PLANNING AND ZONING BOARD STAFF REPORT

Parks at Delray

1690-2350 South Congress Avenue SAD

Meeting	File No.	Application Type
November 16, 2020	2020-277-REZ	Rezoning
Applicant	Property Owners	Authorized Agent
Centerpointe Delray Holdings, LLLP	Centerpointe Delray Holdings, LLLP	Dunay, Miskel & Backman LLP

Exhibit “D”, Master Development Plan

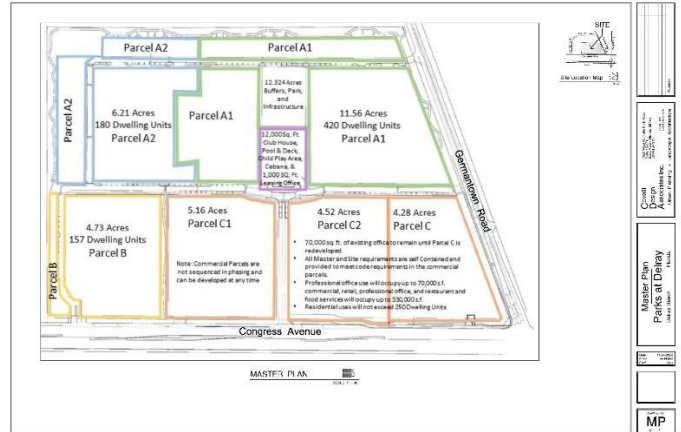
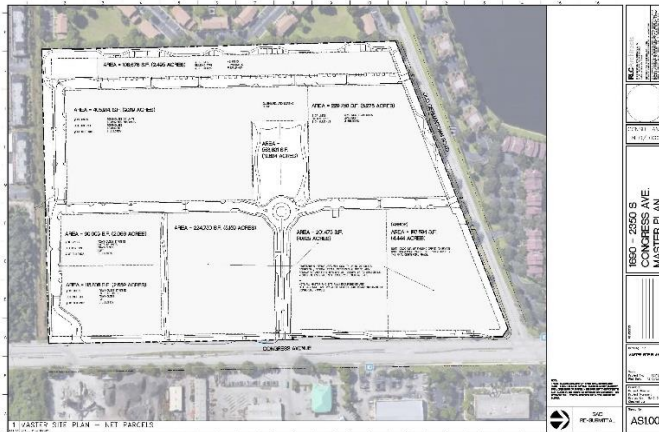
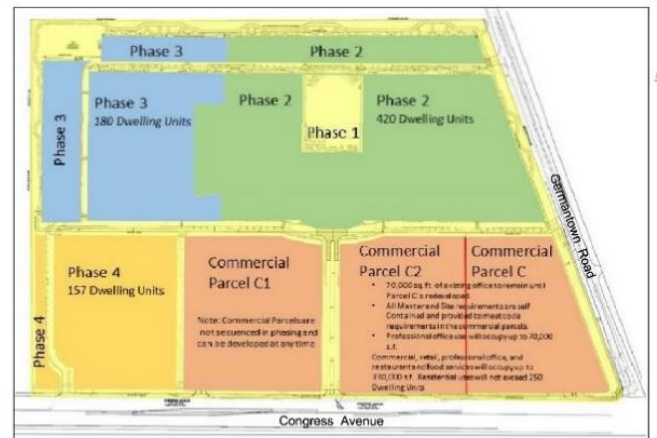
- The timing for the infrastructure improvements so that they are completed prior to the issuance of the first certificate of occupancy (“CO”) for a building, rather than being tied to the issuance of a building permit.
- Modification of standards that conflict with the proposed site plan, such as building setbacks and building separations.
- Clarification of the process for future modifications, including site plans and development standards.
- Amend the MDP to adjust the position of the clubhouse and park and to reflect a change from a roundabout to an intersection in the internal street network.

- **Traffic Calming.** Reference to a roundabout is removed.

The currently adopted and proposed Master Development Plan are provided below and are in the proposed ordinance or attached at a larger scale.
